# Access Compliance Report

## Public Rights-of-Way

### (Curb Ramps)

Intersection ID: 3907	Main Street: ALNWICK_CT	Cross Street: COPPERPLATE_RD	Location: W
ADA ID: 2477EA878507	Ramp Type: Perp	Initial Pass/Fail: Fail	Overall Compliance: No
Severity Score: 1.25			
Codes/Mitigation Info/Possible Solution		Field Measurements/Component Compliance

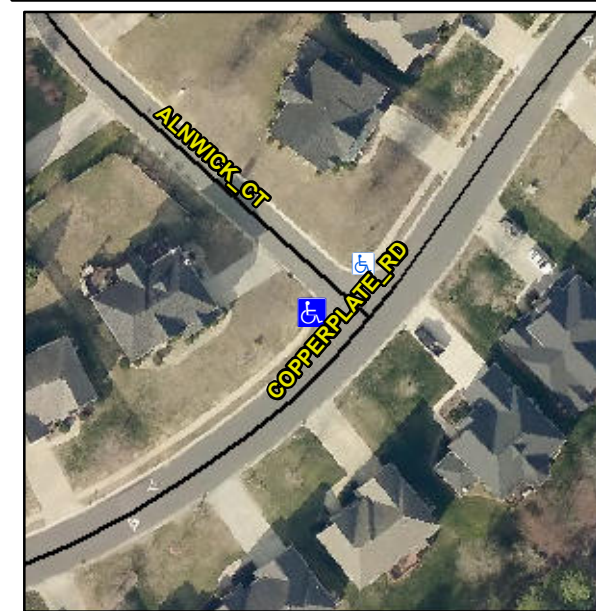
**Not Found, R304.5.3**

Compliance	Description	Data	Compliance	Description	Data
N/A	Ramp Length (in)	49.0	Yes	Ramp Slope (%)	6.1
Yes	Ramp Width (in)	48.0	No	Ramp XSlope (%)	3.6
N/A	Flare Type LT	N/A	N/A	Flare Type RT	N/A
N/A	Flare Slope LT (%)	N/A	N/A	Flare Slope RT (%)	N/A
N/A	Flare Traversable LT?	N/A	N/A	Flare Traversable RT?	N/A
N/A	Landing Length (in)	N/A	N/A	DWS Provided?	N/A
N/A	Landing Width (in)	N/A	N/A	DWS Contrast?	N/A
N/A	Landing Slope (%)	N/A	N/A	DWS Length (in)	N/A
N/A	Landing X Slope (%)	N/A	N/A	DWS Full Width?	N/A
N/A	Landing Curb? (Y/N)	N/A	N/A	DWS Offset (in)	N/A
N/A	Shared Landing?	N/A			
N/A	Gutter Ponding?	N/A	N/A	Gutter Slope (%)	N/A
N/A	Gutter Lip Ht (in)	N/A	N/A	Gutter X Slope (%)	N/A
N/A	Painted X Walk1?	No	N/A	Painted X Walk2?	N/A
	X Walk 1 Direction	To NE		X Walk 2 Direction	N/A
N/A	X Walk 1 Width (in)	N/A	N/A	X Walk 2 Width (in)	N/A
	X Walk 1 Slope (%)	3.7		X Walk 2 Slope (%)	N/A
	X Walk 1 X Slope (%)	1.6		X Walk 2 X Slope (%)	N/A

**Remove & Replace Entire Ramp.**
